Project: IEEE P802.15 Working Group for Wireless Personal Area Networks (WPANs)

Submission Title: [Some discussion for LB #57 comment resolution of Annex G]

Abstract: [This document describes the LB #57 comment resolutions related to Annex G]

LB #57 comment resolutions related to Annex G

Figure G.2 An example of LED signboard operation mechanism

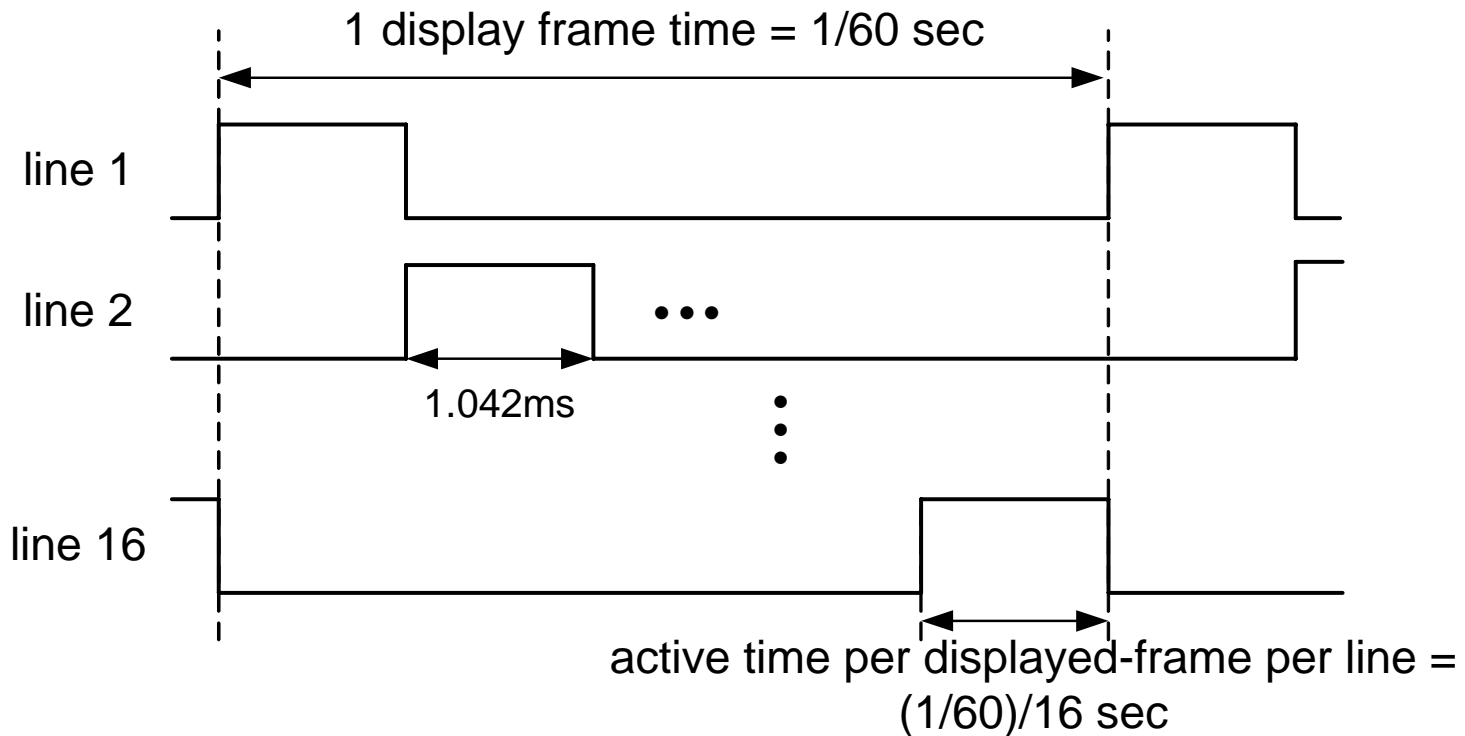
CID	Name	Clause	Subclause	Page	Line	Comment	SuggestedRemedy
408	Rick Roberts	Annex G	Table 91	298	45.5	"potentially faulty reasoning ... more likely I don't understand the thinking! The text says: To maintain the same brightness, even though the VLC data stream reduces the brightness by half, the operating time per line needs to be increased such that 100% duty of 1ms = 50% duty of 2ms = 1ms ON time per second."	The implication is that by reducing the number of pixels per line from 16 to 8, and hence increasing the time duration per pixel by a factor of 2x, then the average intensity will remain the same as the unmodulated case is probably not true. As long as the modulation rate is greater than the flicker frequency threshold, the intensity is decreased by 50% for 100% extinction ratio regardless of the time duration of the pixel, and also regardless of the data rate. At least that is what I think. So my comment is the text at the bottom of page 298 is potentially flawed ... as to the implications on the material in annex G, I don't know that. Committee discussion.

- Figure G.4 shows an example of operation mechanism to mitigate the **average brightness weakness per display frame time** which can arise from when the 16x16 lines LED signboard operated as shown in Figures G.2 and G.3 is used for the VLC and the VLC data is carried during the active time of each line. The **average brightness per display frame time** in Figure G.4 is two times as large as that in Figure G.2 because the active time per displayed-frame per line in Figure G.4 is two times as long as that in Figure G.2.

Figure G.5. An example of broadcast topology construction on VLC LED signboard

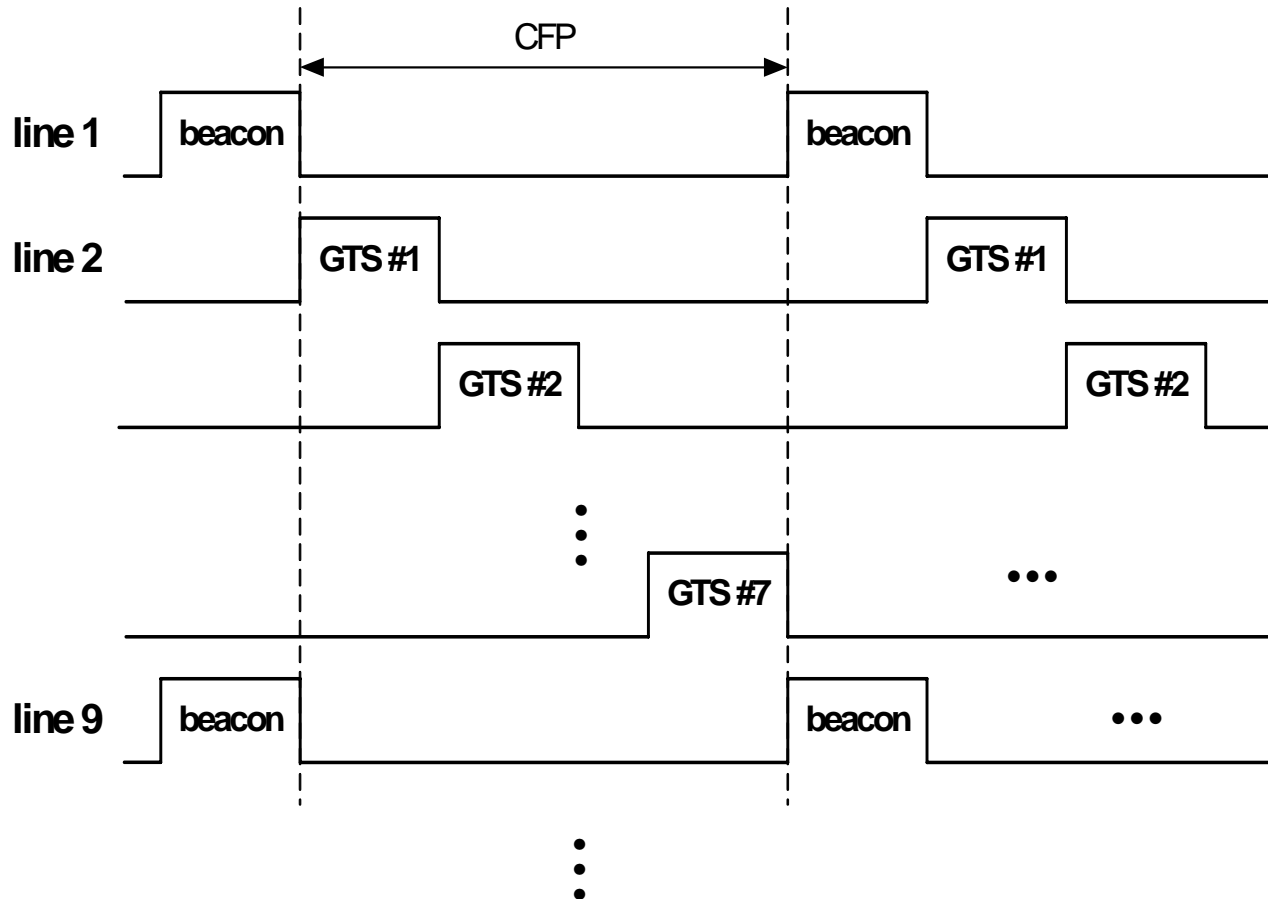
CID	Name	Clause	Subclause	Page	Line	Comment	SuggestedRemedy
410	Rick Roberts	Annex G	Table 91	300	1	modify text as shown in remedy	" ... QoS policy by multiple slot allocations according to the service level as shown in subclause 6.2.2.1. The TDM time slot consists of the beacon slot and the data slot. The beacon slot TS0 is a VLC header for compatibility information with the source address and the destination address, the length field of beacon slot, the service type (information broadcast service or data download service) and the time slot information. The data slot from TS1 to the end of TS is simply the header with the destination address (only for data download service) and no length field."

- The text has been modified and a Figure for the understandings has been inserted.

- The VLC LED signboard can be useful for the broadcast topology. The VLC broadcast topology in this standard consists of mainly the beacon and the downlink, as shown in Figure 106. Therefore, a broadcast topology can be constructed by assigning the active time slot #1 to the beacon and the active time slots from #2 to #8 to the downlink as shown in Figure G.5 and the use of GTS fields in the beacon frame.
- The GTS fields of beacon frame can be used to indicate the GTS number, GTS length, and GTS direction for the broadcast topology. The multiple GTS slot can also be used, which depends on the service level, the subscriber's grade, and the QoS policy.
